# Access Compliance Report

## Public Rights-of-Way

### (Curb Ramps)

Intersection ID: 52304	Main Street: IMPATIE_N_DR	Cross Street: SNOWBELL_CT	Location: SE
ADA ID: C110C7198A27	Ramp Type: PerpDiag	Initial Pass/Fail: Fail	Overall Compliance: No
Severity Score: 10			
Codes/Mitigation Info/Possible Solution		Field Measurements/Component Compliance

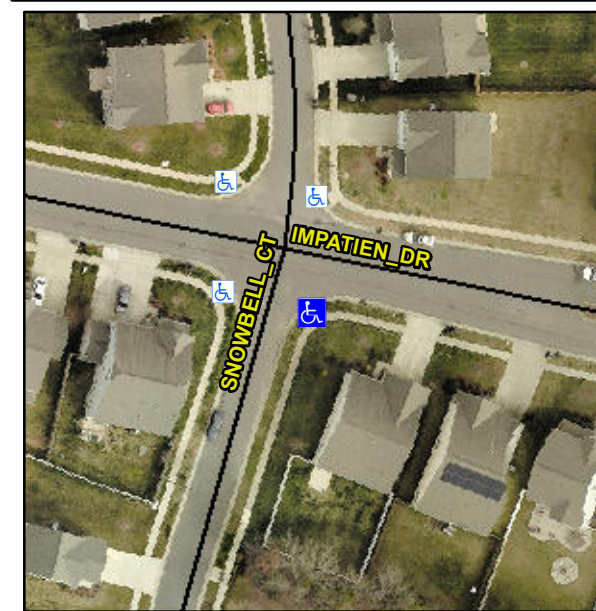
**Not Found, R304.5.1, R304.5.3**

Compliance	Description	Data	Compliance	Description	Data
N/A	Ramp Length (in)	70.5	Yes	Ramp Slope (%)	7.7
No	Ramp Width (in)	39.5	No	Ramp XSlope (%)	2.6
N/A	Flare Type LT	N/A	N/A	Flare Type RT	N/A
N/A	Flare Slope LT (%)	N/A	N/A	Flare Slope RT (%)	N/A
N/A	Flare Traversable LT?	N/A	N/A	Flare Traversable RT?	N/A
N/A	Landing Length (in)	N/A	N/A	DWS Provided?	N/A
N/A	Landing Width (in)	N/A	N/A	DWS Contrast?	N/A
N/A	Landing Slope (%)	N/A	N/A	DWS Length (in)	N/A
N/A	Landing X Slope (%)	N/A	N/A	DWS Full Width?	N/A
N/A	Landing Curb? (Y/N)	N/A	N/A	DWS Offset (in)	N/A
N/A	Shared Landing?	N/A			
N/A	Gutter Ponding?	N/A	N/A	Gutter Slope (%)	N/A
N/A	Gutter Lip Ht (in)	1.0	N/A	Gutter X Slope (%)	N/A
N/A	Painted X Walk1?	No	N/A	Painted X Walk2?	No
	X Walk 1 Direction	To N		X Walk 2 Direction	To W
N/A	X Walk 1 Width (in)	N/A	N/A	X Walk 2 Width (in)	N/A
	X Walk 1 Slope (%)	1.4		X Walk 2 Slope (%)	1.9
	X Walk 1 X Slope (%)	2.1		X Walk 2 X Slope (%)	0.1

**Remove & Replace Curb Ramp With Two New Directional Ramps or Equivalent.**
